PUBLIC HEARING/WORKING SESSION MEMORANDUM

PETITIONS #26-20 & #27-20

355 and 399 Grove Street

Graphic I: Initial Bicycle Facilities from 2019

Graphic II: Current Bicycle Facilities

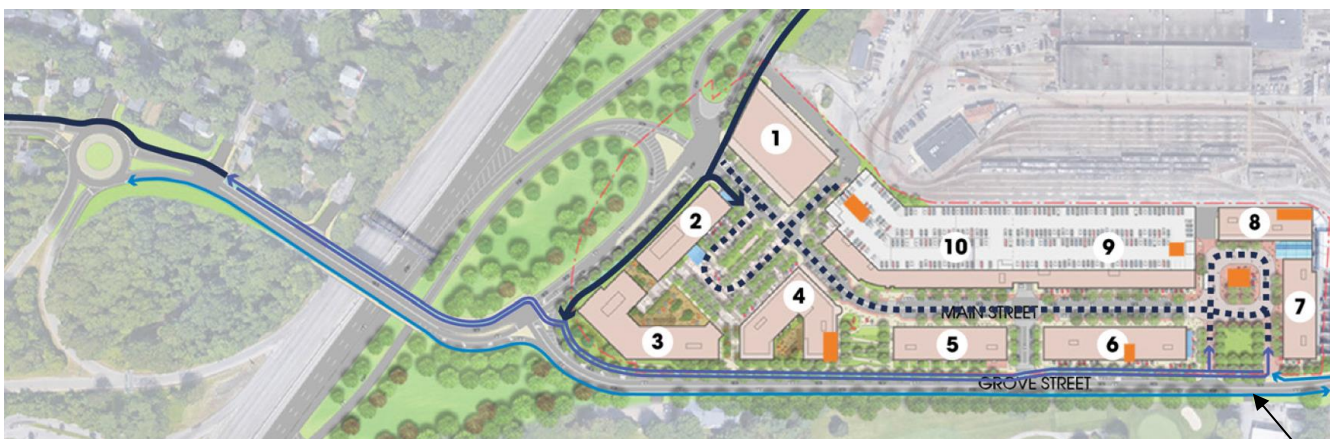
Due to comments regarding the northbound raised bike lane at the February 25th and at the April 7th hearings, the petitioners provided four alternatives for bicycle facilities on Grove Street: Alternative A includes both the two-way cycle track and the northbound bicycle lane; Alternative B includes both the

two-way cycle track and the one-way bicycle lane on the eastern side of Grove Street, but this lane is raised six inches; Alternative C mirrors the first iteration of the Project with only the two-way cycle track on the west side of Grove Street; and Alternative D provides for a one-way southbound bicycle track on the west side of Grove Street and a one-way northbound bike lane on the east side of Grove Street. The petitioners are not proposing to widen Grove Street; therefore, these Alternatives exhibit how the space between the buildings and the eastern boundary of Grove Street can be allocated. In order to evaluate these different options, this memo will take them out of order to show how the Project has evolved and to illustrate how the different facilities affect the section of Grove Street, specifically in front of Buildings 5 and 6.

Alternative C: Two-Way Cycle Track

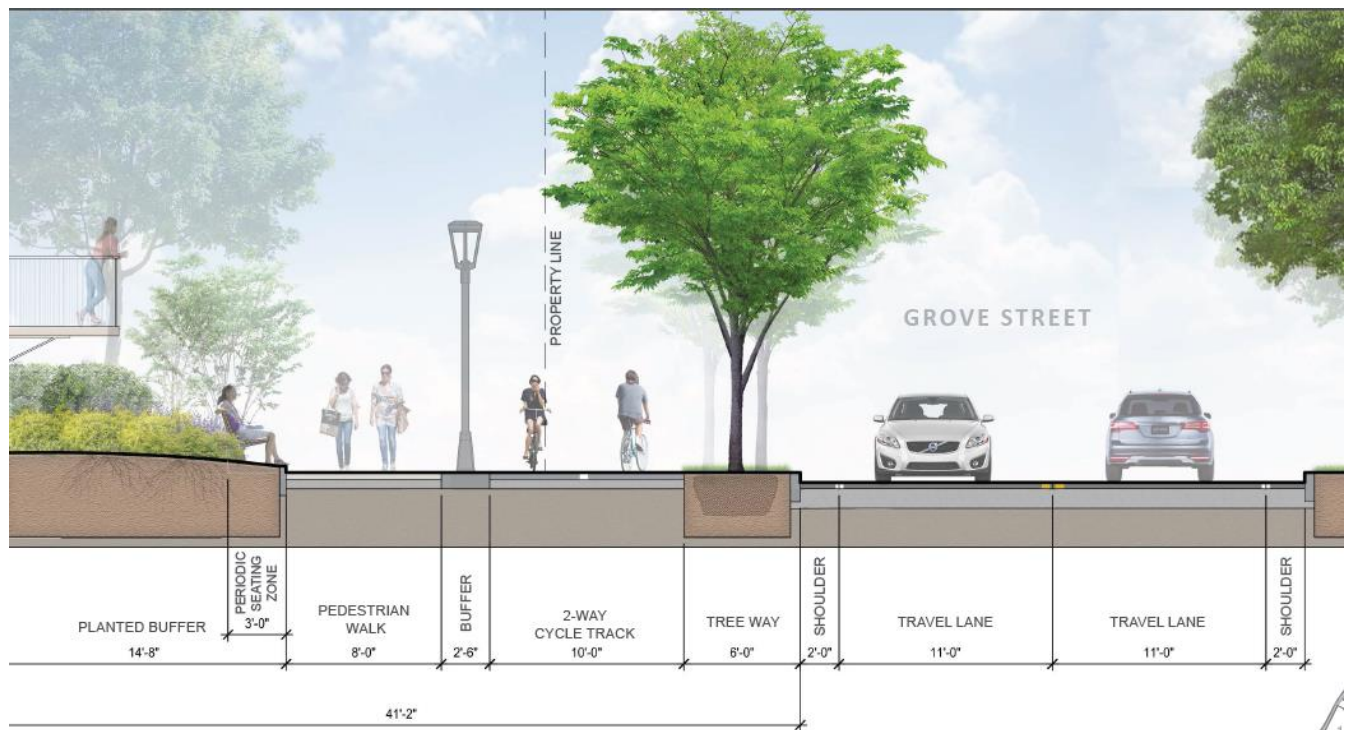
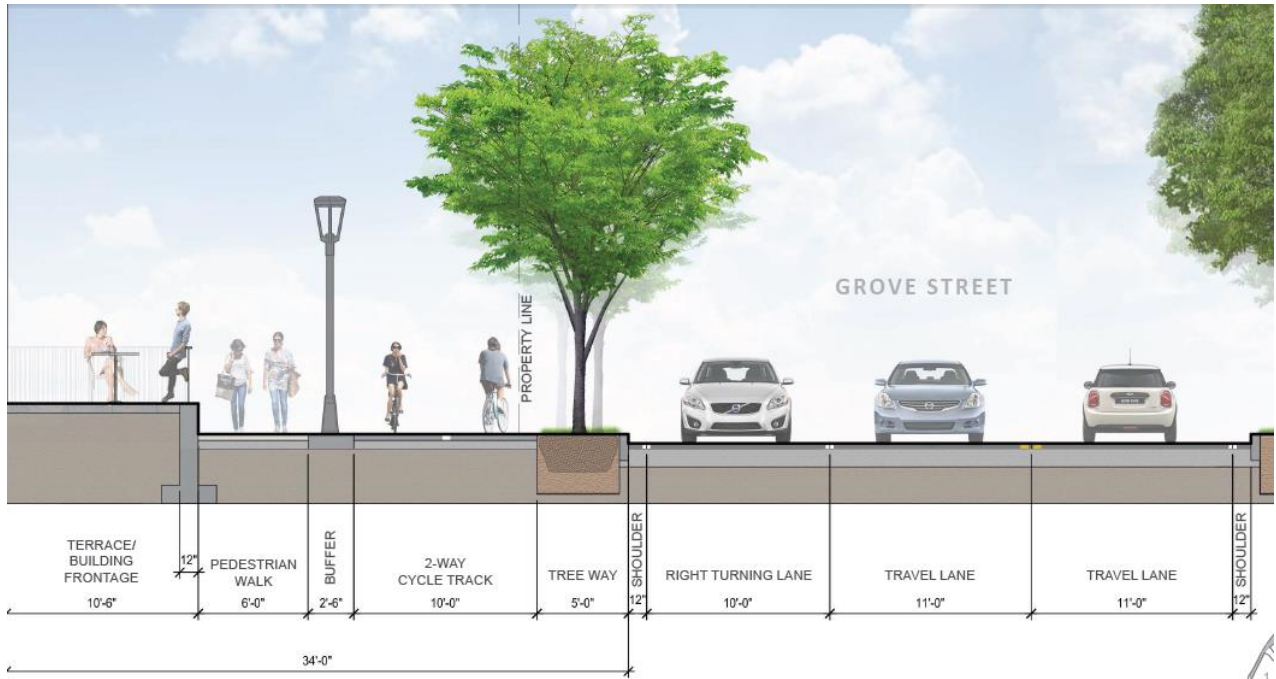
As stated above, Alternative C most closely represents the beginning of the Project and allows for a baseline of how the section is affected by the different facilities.

Alternative A: Two-Way Cycle Track and Unprotected Bike Lane

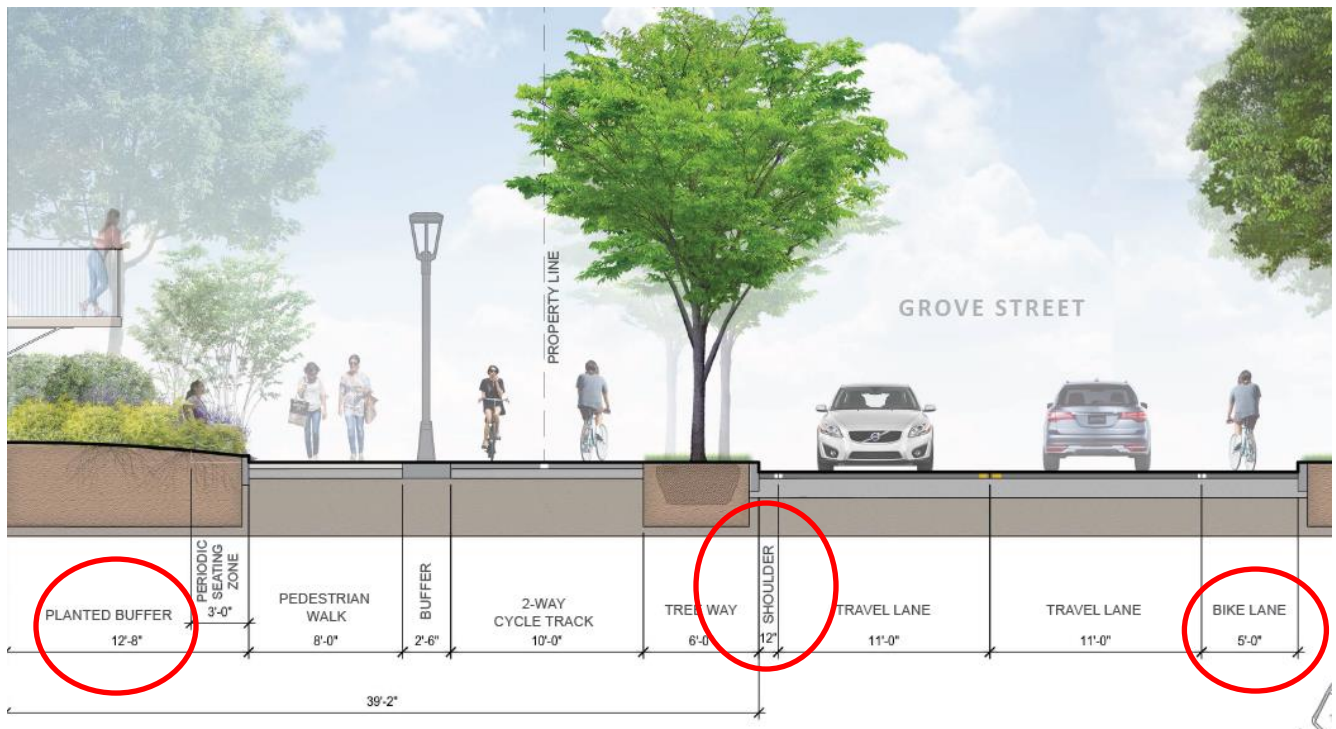
To accommodate the northbound bike lane, the *Planted Buffer* is reduced from fourteen feet eight inches to twelve feet eight inches, the two-foot wide *Shoulder* separating the southbound vehicular

travel lane from the *Tree Way* is reduced by one foot, and the two-foot wide *Shoulder* separating the northbound vehicular travel lane from the curb is removed. This additional space is used to create the five-foot wide bike lane.

Building 6

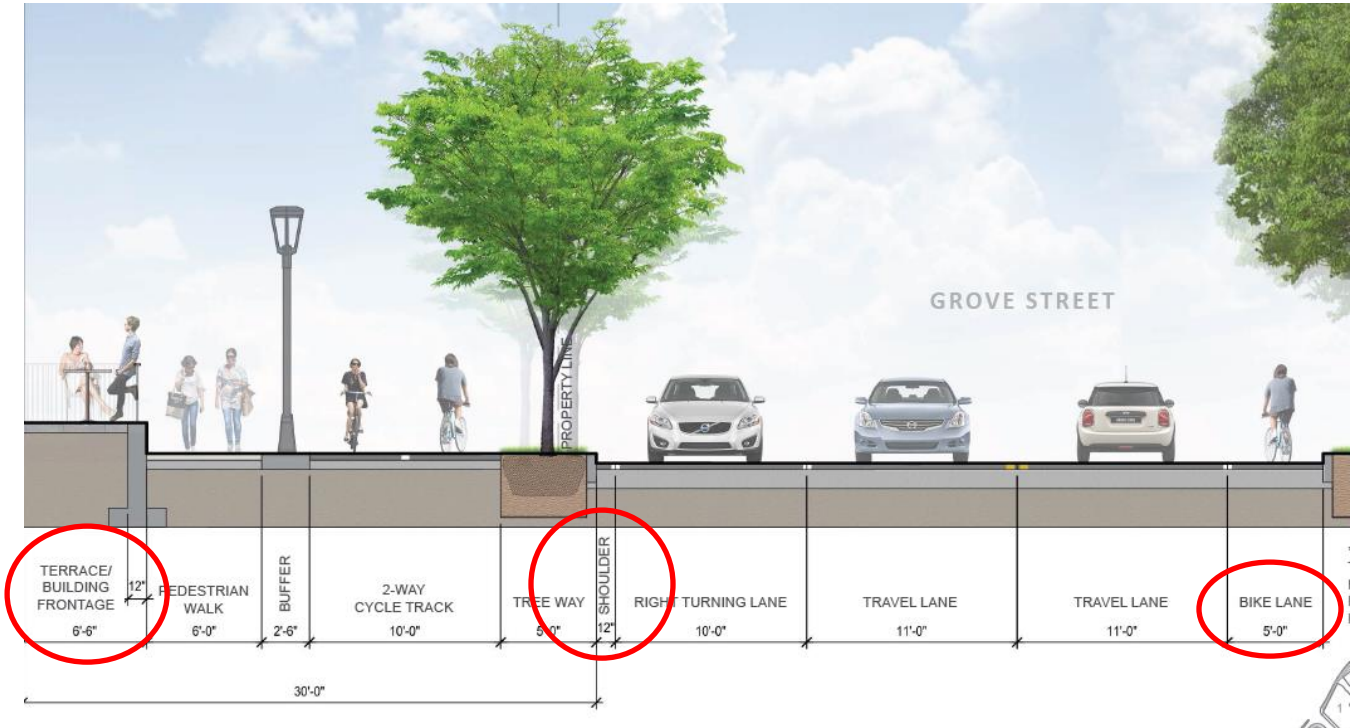
To accommodate the northbound bike lane, the *Terrace/Building Frontage* is reduced from ten feet six inches to six feet six inches, the one-foot wide *Shoulder* separating the southbound vehicular travel lane from the *Tree Way* is maintained, and the *Shoulder* separating the northbound vehicular travel lane from the curb is removed. In this scenario the northbound bike lane is provided, which staff supports, but it is not protected from vehicular traffic. As such this alternative is not preferred.

Alternative B: Two -Way Cycle Track and Protected Bike Lane

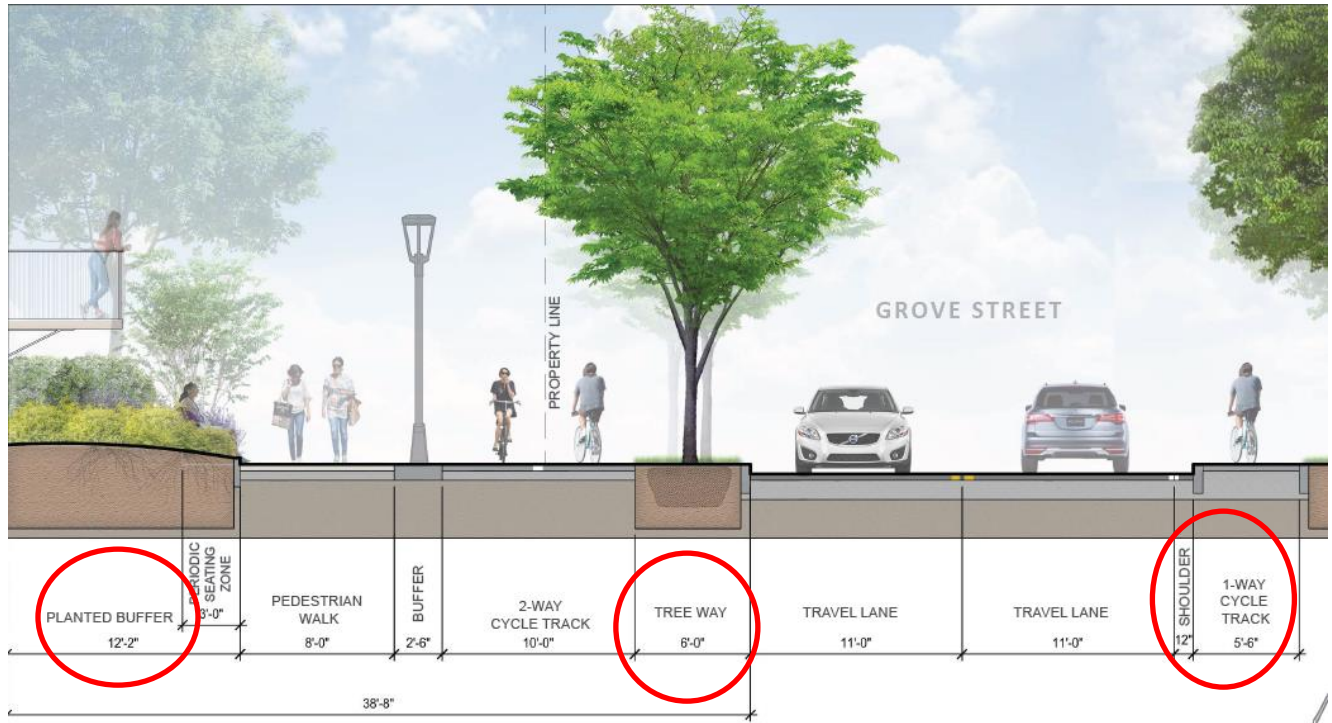
The *Planted Buffer* is reduced from fourteen feet eight inches to twelve feet two inches, the two-foot wide *Shoulder* separating the southbound vehicular travel lane from the *Tree Way* is removed, and the two-foot wide *Shoulder* separating the northbound vehicular travel lane from the curb is reduced to one foot.

Building 6

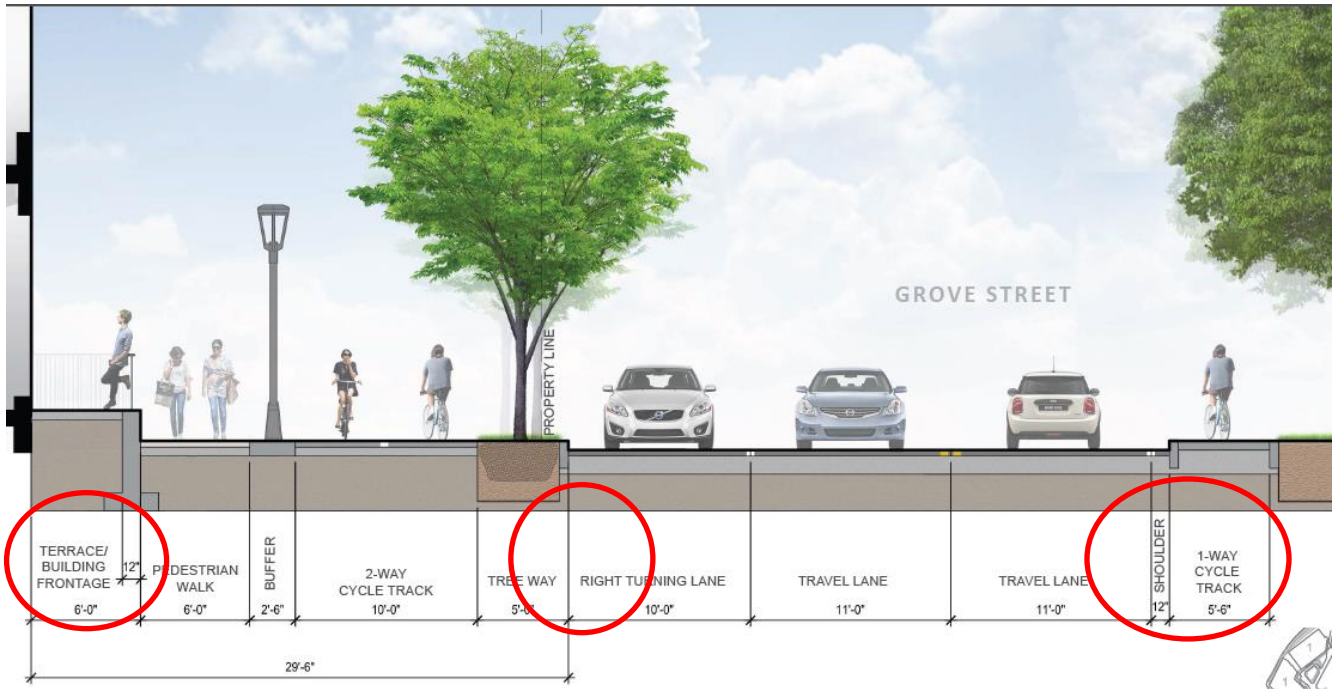
The *Terrace/Building Frontage* is reduced from ten feet six inches to six feet, and the one-foot wide *Shoulder* separating the southbound vehicular traffic from the *Tree Way* is removed. In this scenario the northbound bike lane is provided and is raised which is the condition City Staff prefers. The bike lane is also buffered from the northbound vehicular travel lane by a one-foot wide *Shoulder*, increasing safety for the bicyclist.

Alternative D: One-Way Bike Lanes

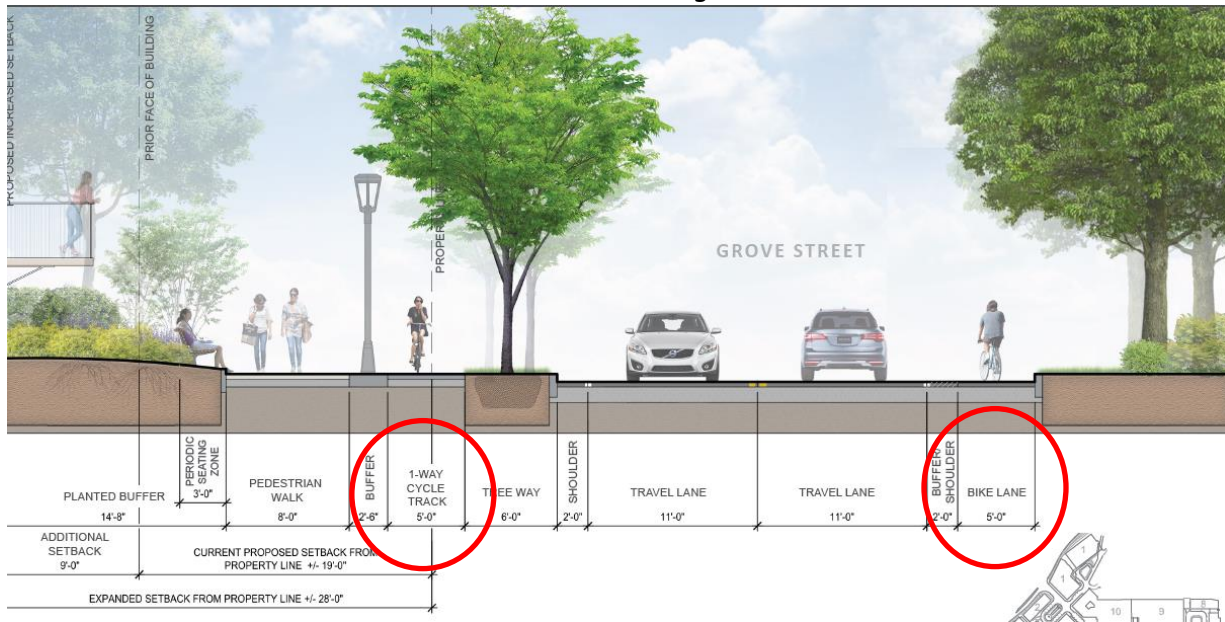
In this alternative, the two-way cycle track on the west side of Grove Street is reduced to a one-way southbound bike lane. This allows for all the dimensions to be maintained and allows for the bike lane on the eastern side of Grove Street to be buffered by two feet.

Building 6

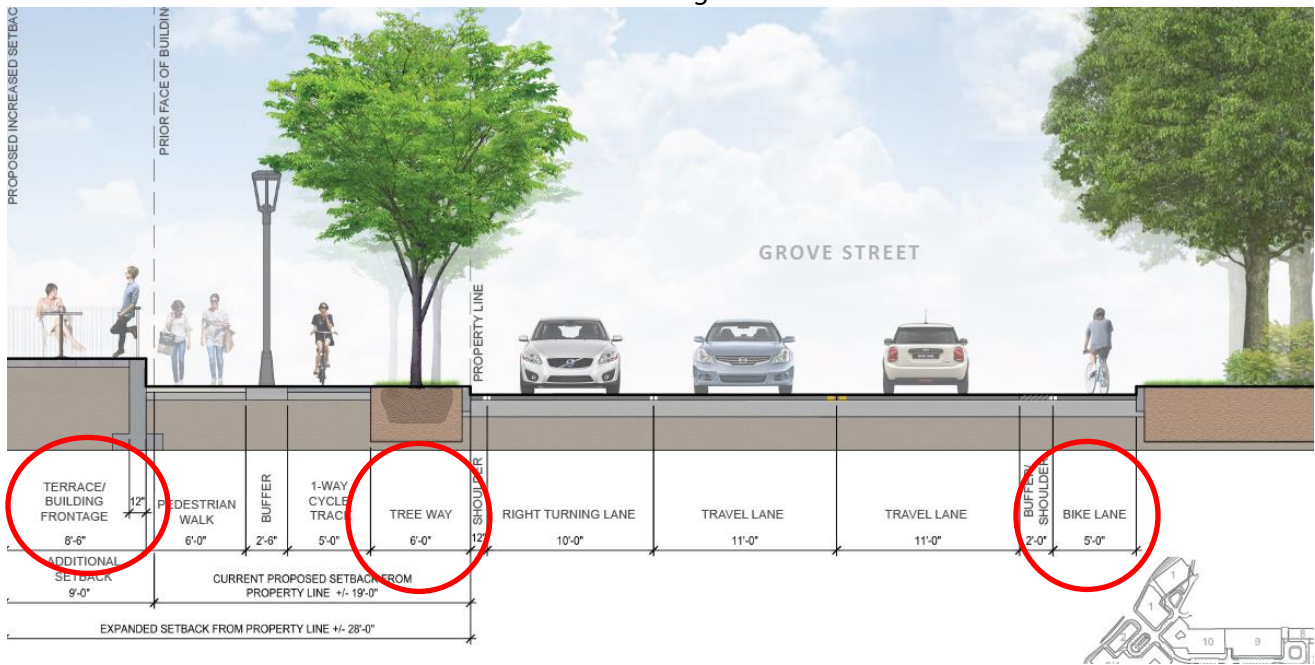
The *Terrace/Building Frontage* is reduced by two feet to eight feet, six inches, the *Tree Way* is increased by one foot, from five feet to six feet; and the bike lane on the eastern side of Grove Street is buffered by two feet.

This Alternative solves for the three conditions that were identified in the petitioners’ first plan and still allows for a protected southbound bicycle lane on the eastern side of Grove Street. However, this Alternative removes the opportunity for residents from the western side of Lower Falls to access the site without crossing Grove Street. While staff’s concerns with the first design focused on trips traveling past the site, this Alternative does not account for the expected increase in short-distance trips from Lower Falls to the site. Staff believes that this Alternative does not realize the opportunity this Project presents to create a unique amenity such as the two-way cycle track while accounting for future trips from Lower Falls into Auburndale.
